**CITY OF MISSOURI CITY  
PLANNING AND ZONING COMMISSION AGENDA**

**SUBJECT:** Sienna Village of Destrehan Section 6B - Preliminary Plat

**SUBJECT:** Sienna Village of Destrehan Section 7B - Preliminary Plat

A PRELIMINARY PLAT OF  
**STONEBROOK AT RIVERSTONE SECTION TWO**  
116 LOTS (50'x60' X 110' TYP.)  
MARCH 20, 2015  
SHEET: 2 OF 2  
SCALE: 1" = 100'

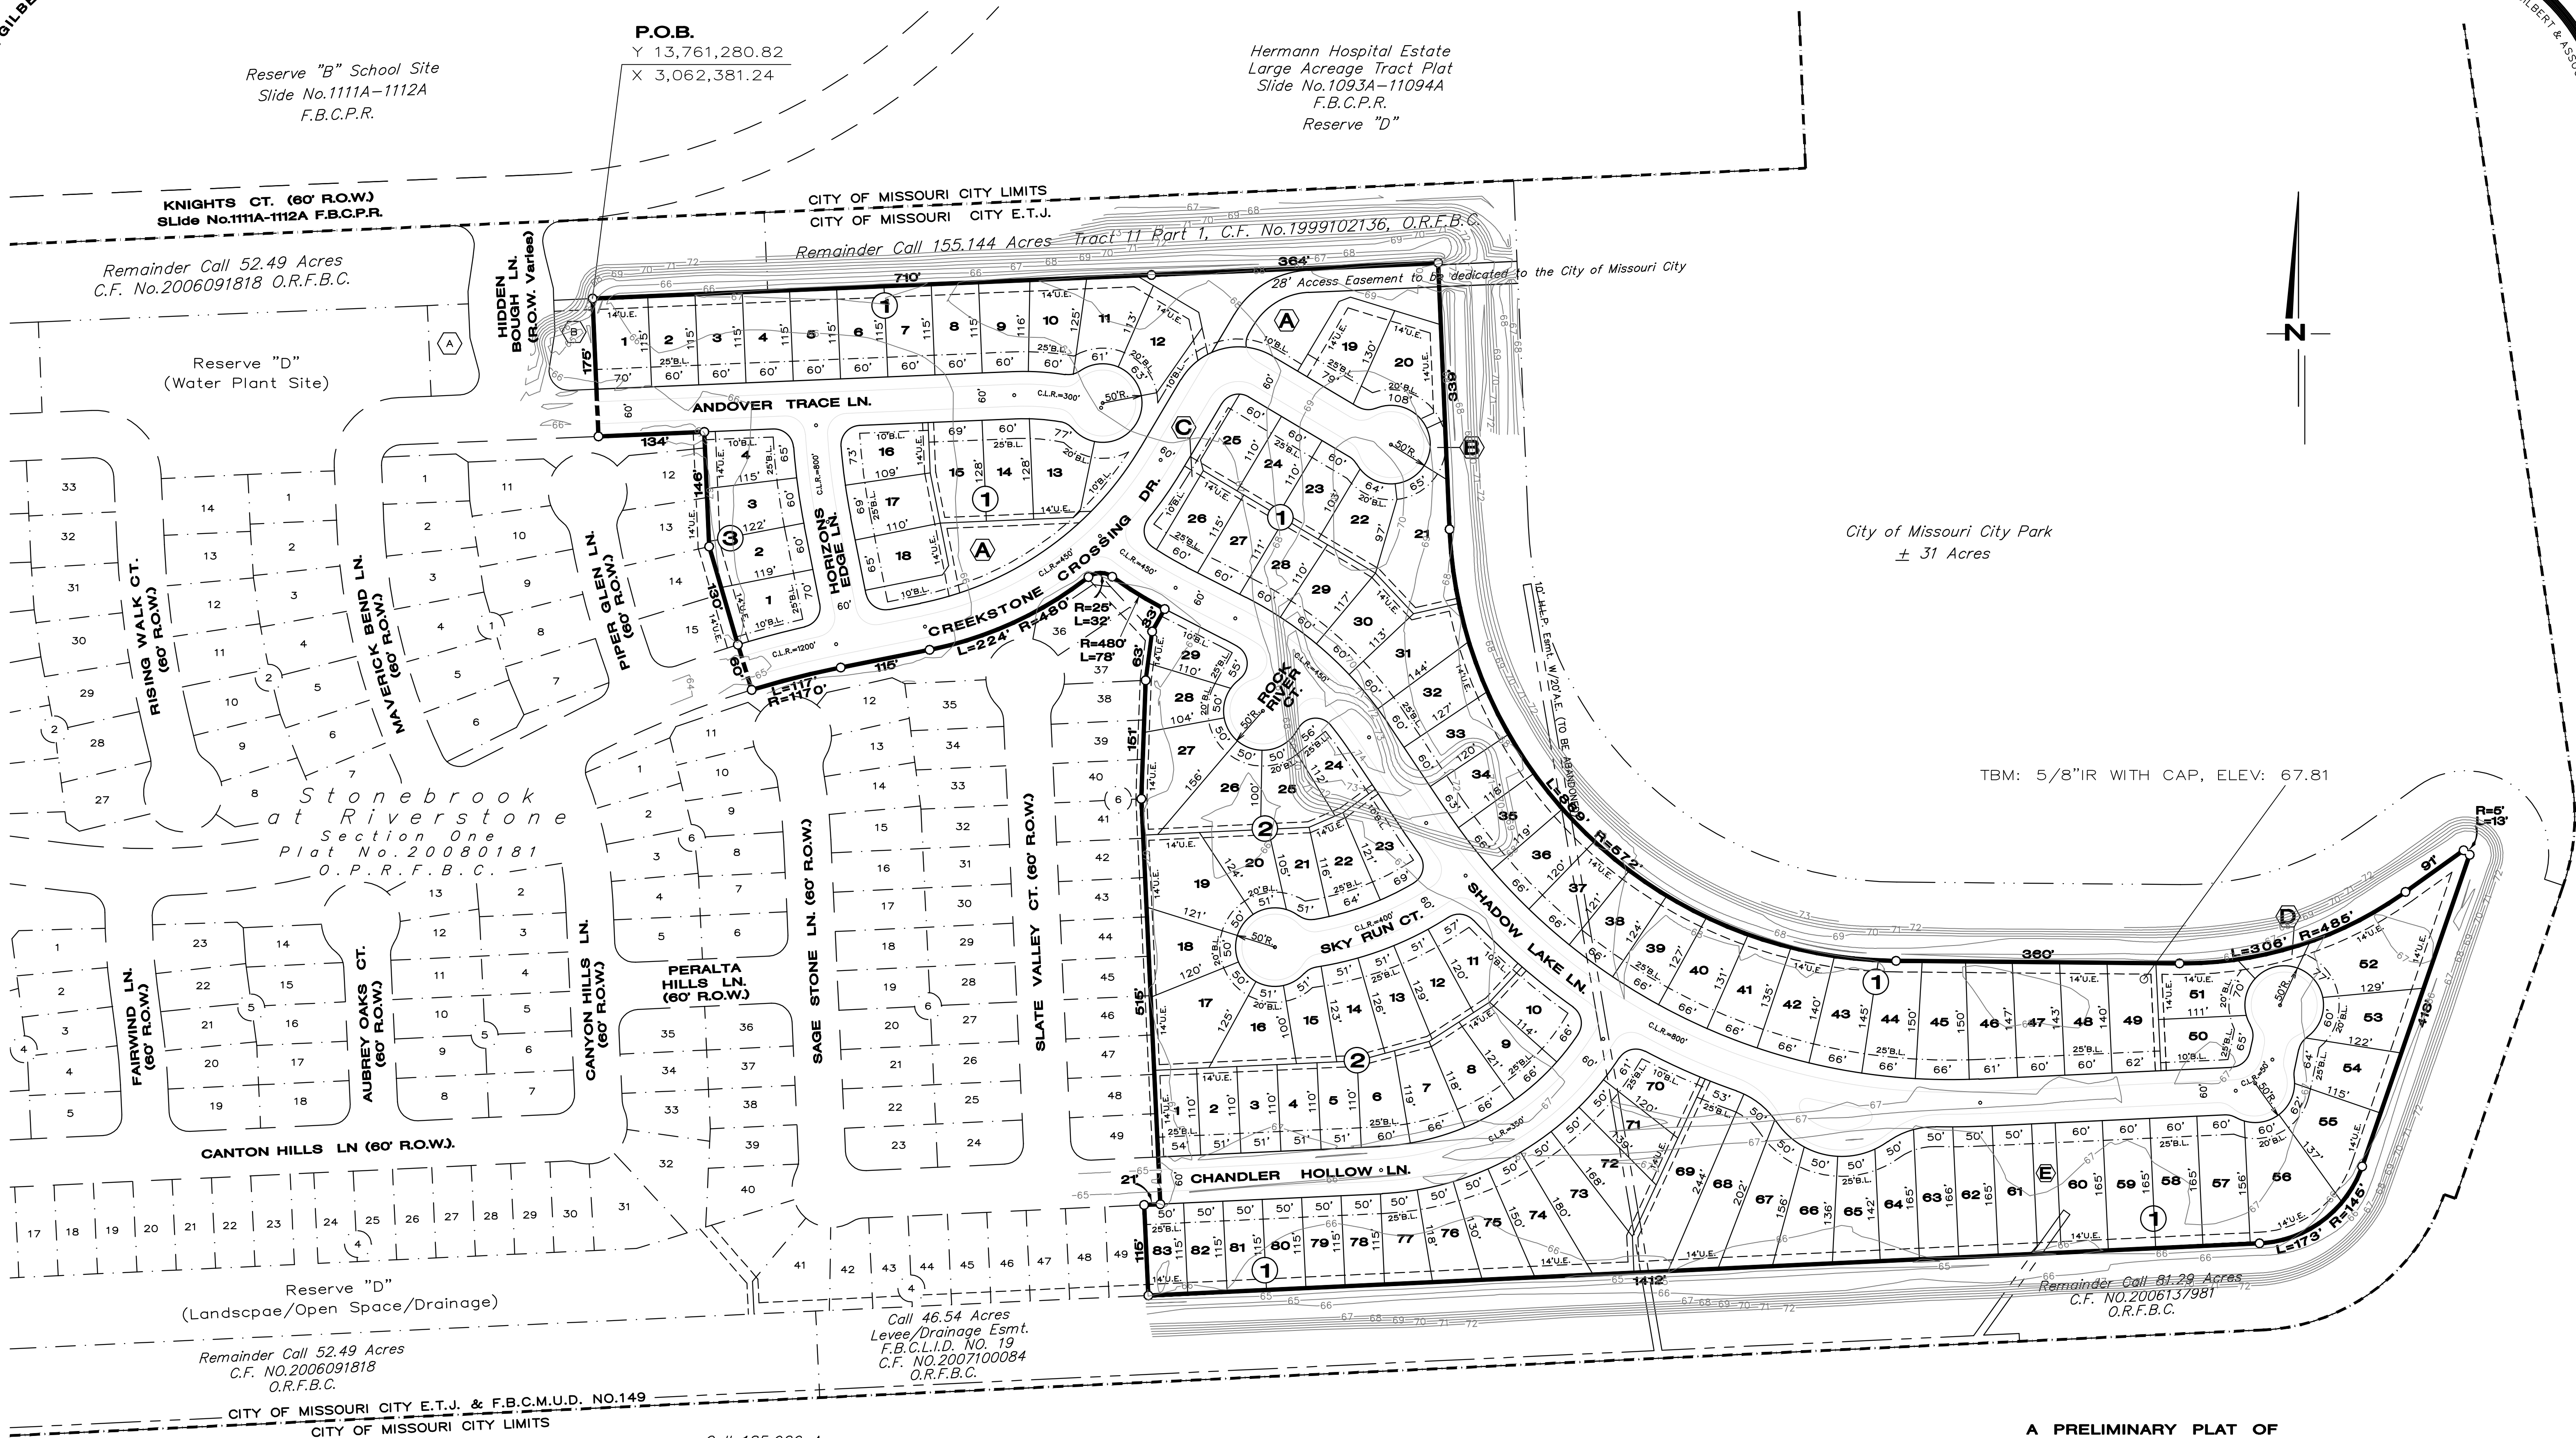
1. A revised conceptual plan should be submitted. Conceptual plan for the subject site was originally approved in 2007 and a final plat for Section One approved in 2008. The Concept Plan should be revised to show the proposed changes to Section Two.
2. A preliminary utility plan with calculations must be provided in accordance with Section 2.D(19). Utility models for water and sanitary are required per Chapter 5.02 and 6.02 of the City's Public Infrastructure Manual. Additionally, minimum fire flow and minimum system pressure information is required.
3. Traffic Impact Analysis has not been approved by the City Engineer. **Please contact City Engineer for information.**

1. Radius on Chandler Hollow Lane and Sky Run Court does not meet the requirements of the City of Missouri City Infrastructure Design Manual, Section 11. **Please revise.**

2. Knuckle configuration on Shadow Lake Lane between lots 64-68 does not meet the requirements of the City of Missouri City Infrastructure Design Manual, Section 11. **Please revise.**
3. The **boundaries of political subdivisions and school districts** within or adjacent to the subdivision for a distance of not less than 200 feet must be indicated in accordance with Section 2.D(12). **City of Missouri City limit is inaccurately indicated on the plat and vicinity map. Please revise.**
4. The location, rights-of-way widths, and names of all existing and proposed easements, including pipeline, within or adjacent to the subdivision for a distance of not less than 200 feet shall be indicated in accordance with Section 2.D(12). **Please indicate all easements within 200 feet of the proposed subdivision.**
5. Please provide a signed copy of the Encumbrance Certificate.
